Karachi Municipal Corporation.

Case No. P/4 176/35

Re: Plot No.7, S.R.5, Serai Quarter.

PROPOSED ADDITIONS IN BUILDING ON PLOT No 7 SHEET 1R.5.

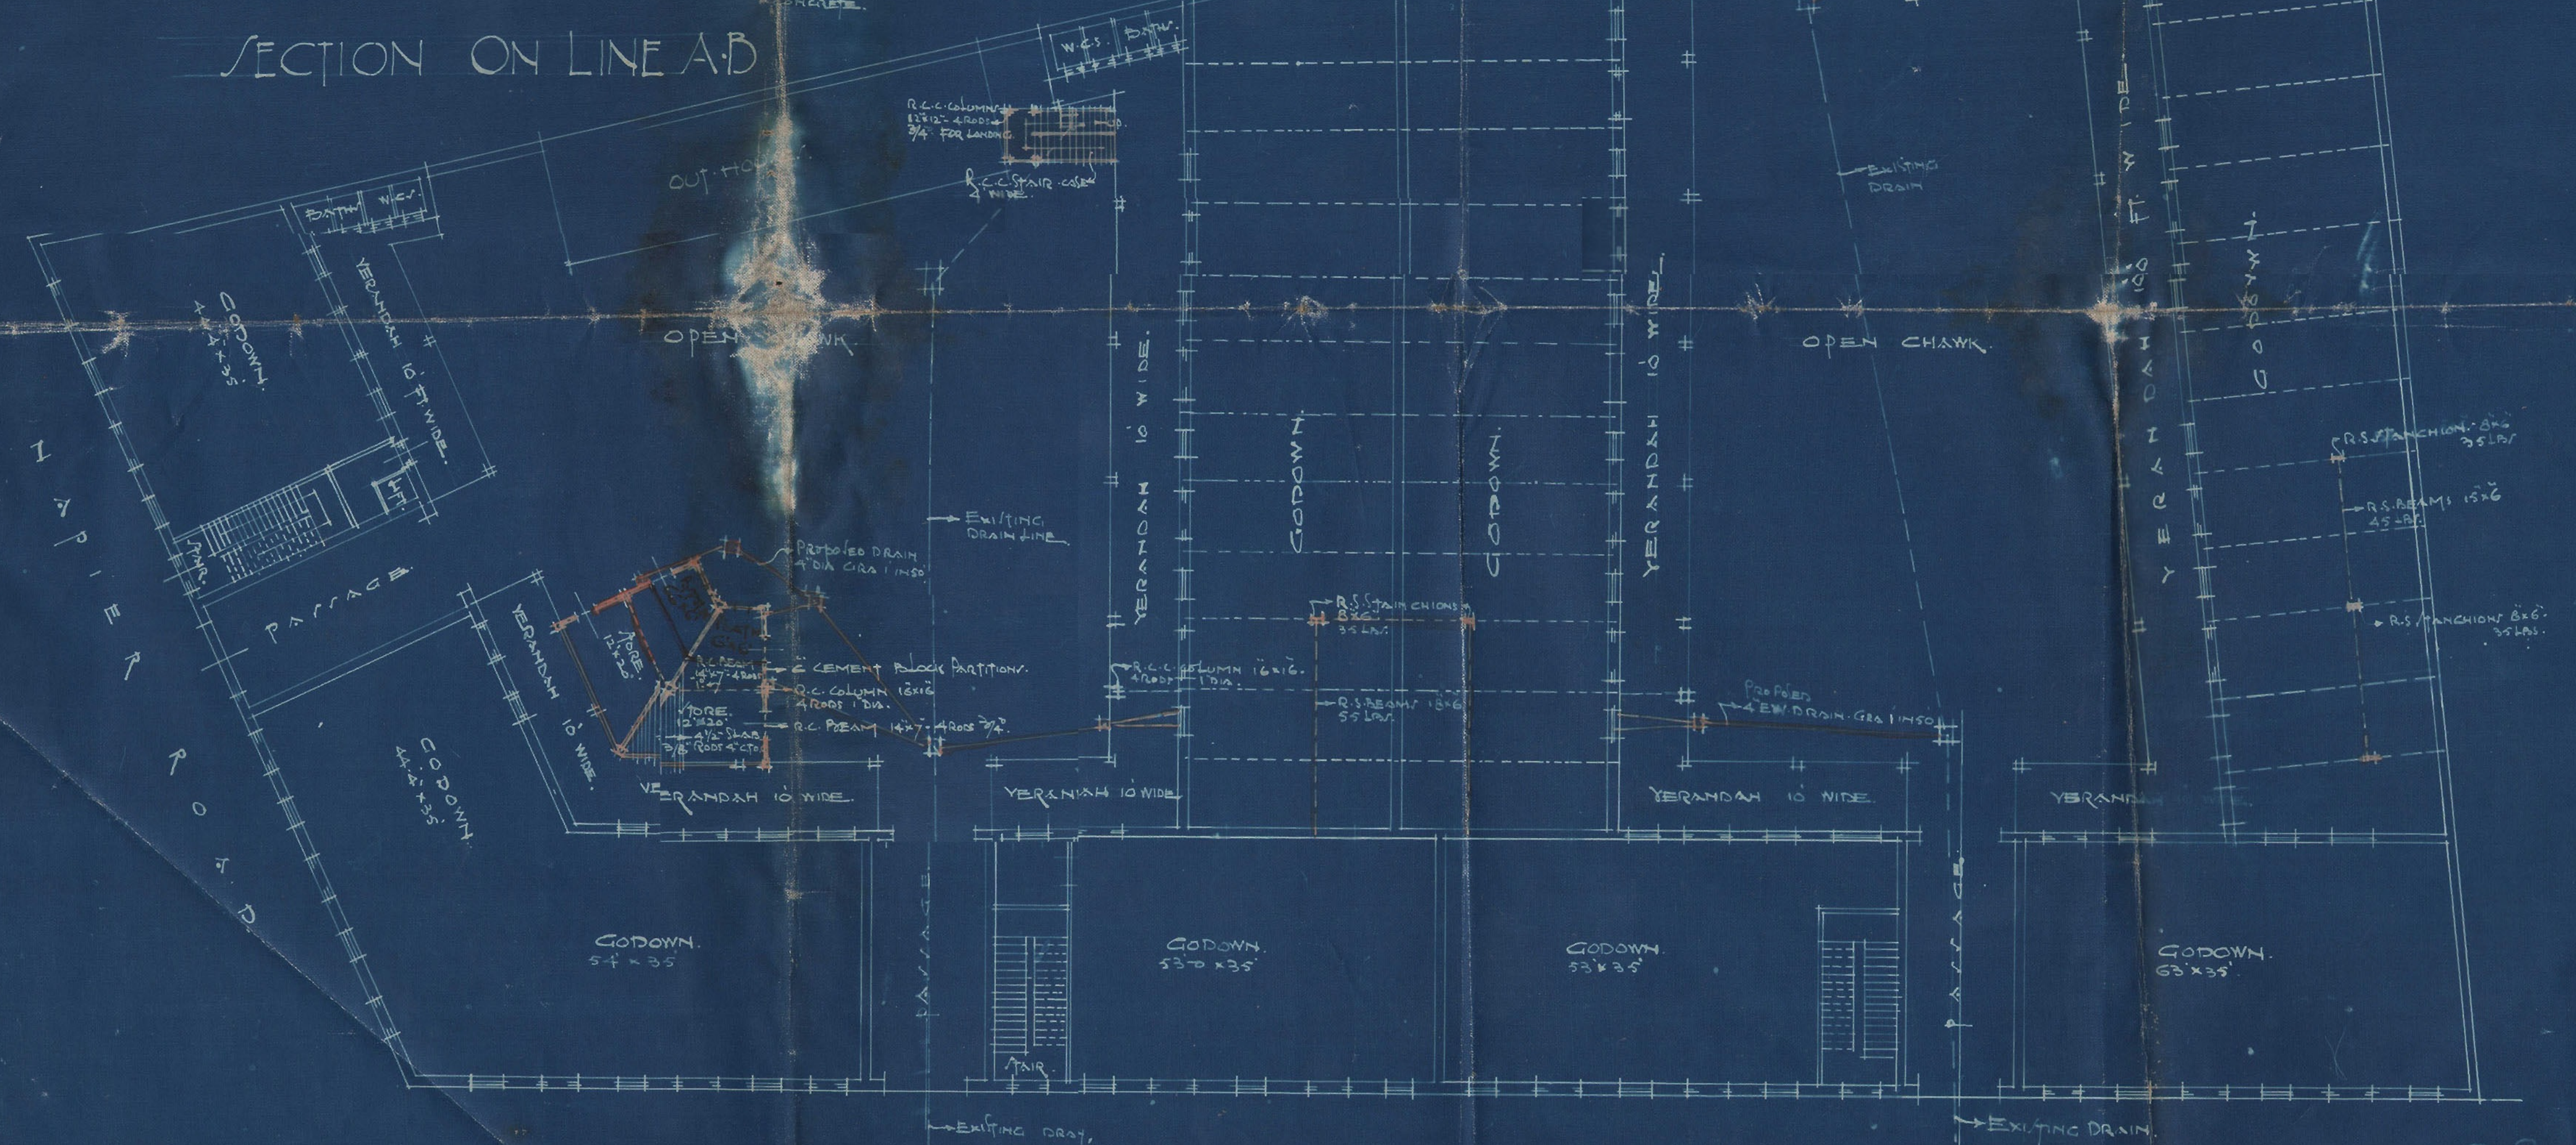
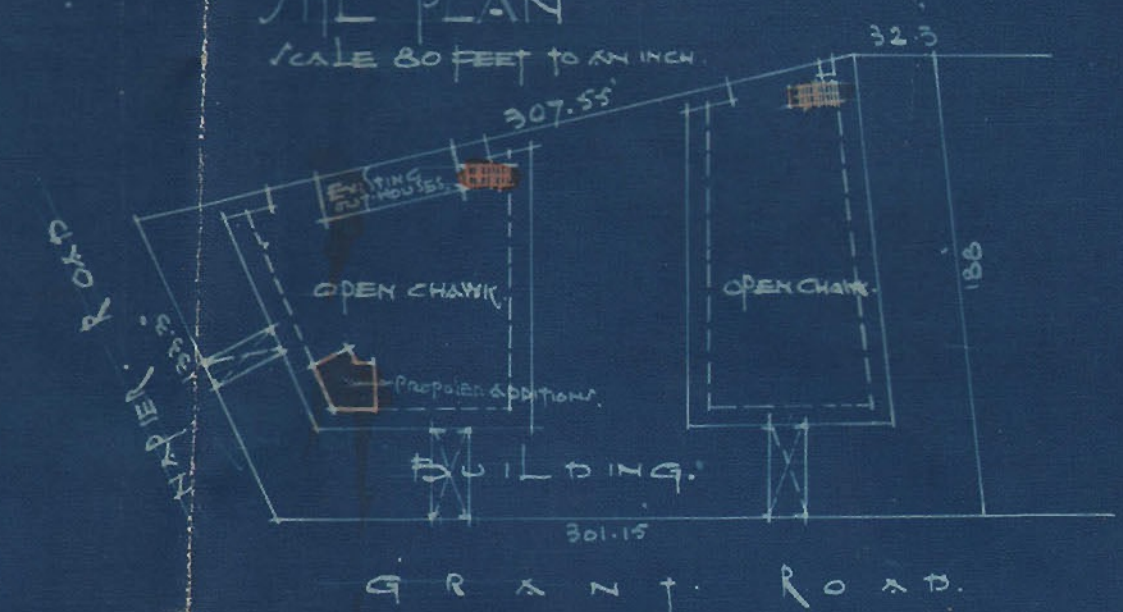
① W.C's over Verandahs and stores are against rule.

corrective ② Letter on 9th floor requires correction.

The architect Law me and his idea is that the Verandahs are more or less passages and there should be no objection to the W.C's over the same.

The owner of the above plot has submitted plan showing w.c.s. on upper floors over open verandans.

Plan to be approved.

Plan to be approved
2/4
